TECHNICAL SERVICE BULLETIN

TSB#: **16-032**

Inspect engine door actuator harness plugs for correct pin styles.
Install new adapter harness when inspection finds incorrect pins.

Fig 4: Inspect the male connector to confirm it has male pins inside the connector.

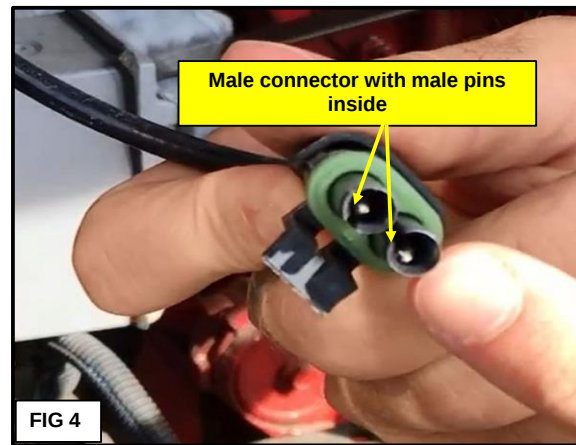
- 3 Inspect the pins inside the connectors on both actuator harnesses (**Fig 2 & 3**)

Fig 6: If male pins are located on female connector, the adapter harness is required.

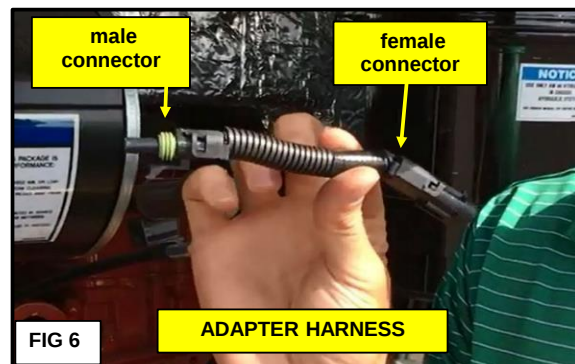
- 4 **Fig 5:** Inspect the female connector to confirm if incorrect male pins are present.

- 1 **Fig 7:** Plug the actuator harness male plug into the **adapter** harness **female** plug.

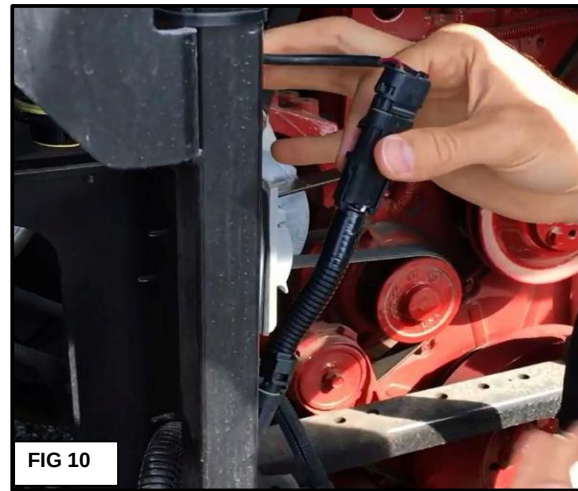
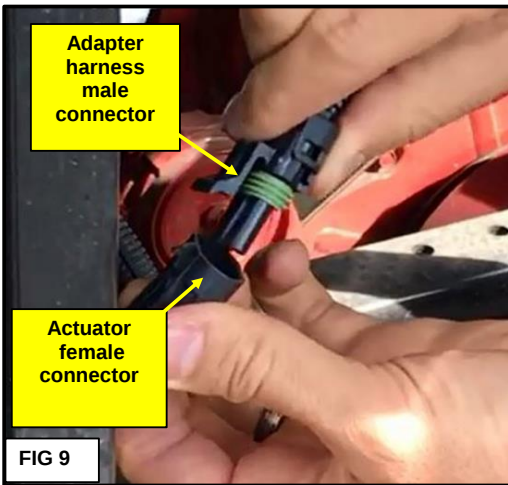
Fig 8: Shows connection of actuator harness and adapter.

- 4 Fig 5: Inspect the female connector to confirm if incorrect male pins are present.
 Fig 6: If both connectors of the actuator harness have male pins, the adapter harness is required.

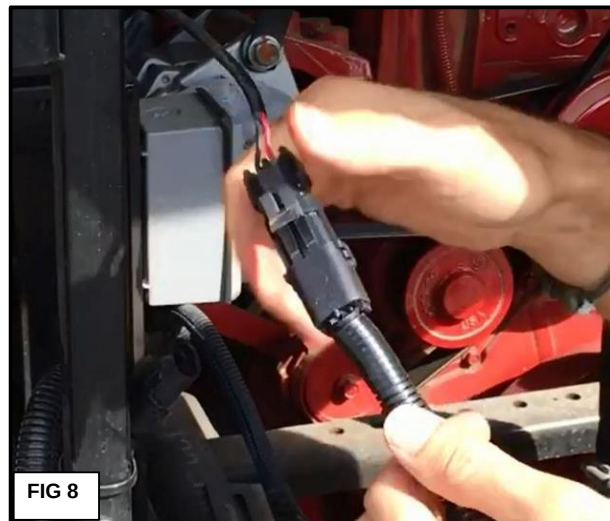
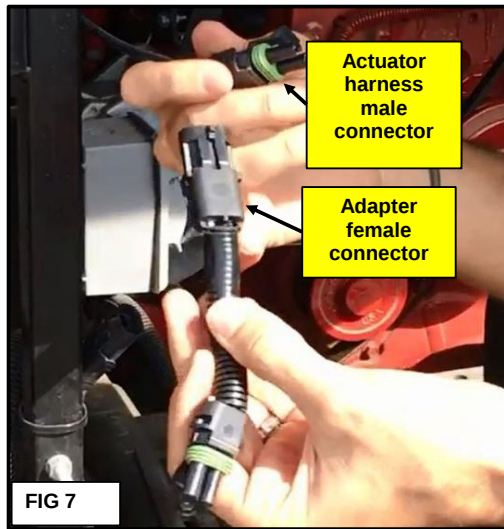
- 3 Inspect the pins inside the connectors on both actuator harnesses (Fig 2 & 3)
- Fig 4: Inspect the male connector to confirm it has male pins inside the connector.

- 2 Fig 9: Plug the actuator harness female plug into the adapter harness male plug.
 Fig 10: Shows connection of actuator harness and adapter.

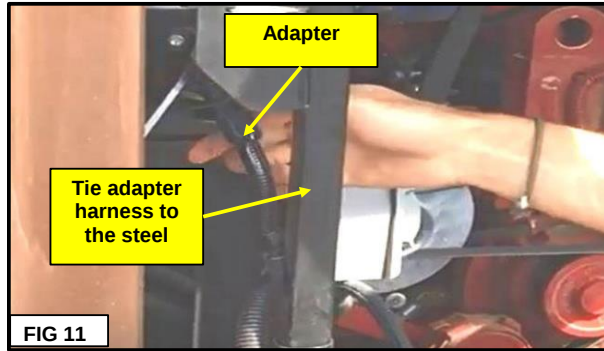
- 3 Fig 11:** Attach the adapter harness to the steel support tube using wire tie. Repeat steps 1-3 if required on opposite side of the engine compartment.
